**STAFF REPORT
HOLLISTER PLANNING COMMISSION
MEETING DATE: September 25, 2025
REPORT # Community Development-2025-60**

AGENDA ITEM: 89 THIRD STREET SITE & ARCHITECTURAL REVIEW 2025-6

RECOMMENDED ACTION: Adopt a resolution denying Site & Architectural Review 2025-6 for APN: 054-162-001 located at 89 Third Street in the Neighborhood Mixed-Use Zoning District.

Figure 2: Site Plan

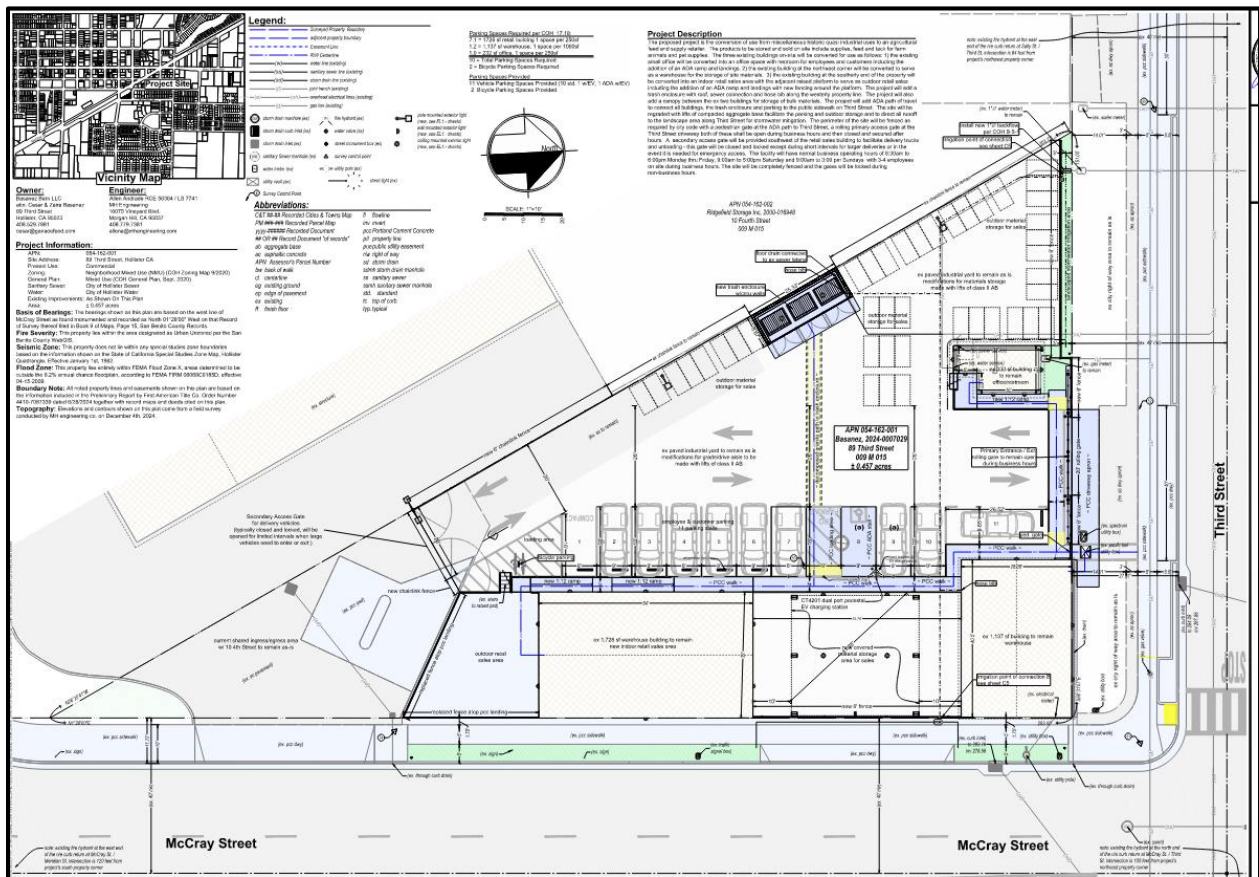
While the project largely complies with the requirements of the commercial and mixed-use general development standards and mixed-use zoning district supplemental standards outlined in Hollister Municipal Code (HMC) Chapter 17.08 – Commercial Zone Land Uses and Permit Requirements of the Hollister Municipal Code, the proposed project does not comply with the requirements of HMC Section 17.18.110 – Design and Development Standards for Off-street Parking. The project proposes to surface the project site with an unspecified thickness of Class II AB material (combination of gravel/rock and rock dust in powder like form) as shown on sheets C1-C3. Per HMC Section 17.18.110(Q) *Surfacing*, “all off-street parking lots shall be surfaced with four inches of Portland Cement Concrete, or two inches of asphaltic concrete, or oil surfacing, placed on four inches of suitable base and built to a thickness which meets city street standards, subject to the approval of the Director/City Engineer.”

Furthermore, Class II AB falls under the category of “macadam surface,” according to the State Regional Water Quality Control Board, an impervious surface which impedes the natural infiltration of stormwater, the material does not comply with the requirements outlined in HMC 17.16.140. Per HMC 17.16.140(A)(1), “all new development and redevelopment post-construction drainage improvements shall be designed in accordance with the requirements of the California Regional Water Quality Control Board, Central Coast Region, Resolution R3-2013-0032 or subsequent amendments thereto, as applicable.” Per Resolution R3-2013-0032(B)(c), “the permittee shall apply the Post-Construction Requirements by March 6, 2014, to all applicable Regulated Projects that require approvals and/or permits issued under the Permittee’s planning, building, or other comparable authority.”

As the proposed project seeks to redevelop and or replace greater than 2,500 SF of impervious surface, the project meets the classification of a Regulated Project. As such, because the project seeks to regrade the existing Class II AB surface, the project does not comply with the requirements of the City of Hollister and the California Regional Water Quality Control Board Post Construction Stormwater Requirements.

The resurfacing must be shown on the plans and the preliminary stormwater post-construction stormwater requirement information submitted so that the City can perform

an adequate review and ensure that the ultimate design will meet the City's requirements and standards prior to recommending approval of the project to the Commission. The requirement cannot be conditioned on the project because the change may require additional modifications to the site plan in order to meet all requirements and standards. For this reason, staff is recommending denial of the project per the applicant's request, rather than recommending approval with a condition of approval calling for the amendments to be made at a later date (such as during improvement plan review). This is the only outstanding item that is unaddressed that is leading to staff's recommendation of denial. If the applicant were to revise their plans to address the Engineering Division's comments, staff could recommend approval of the project.
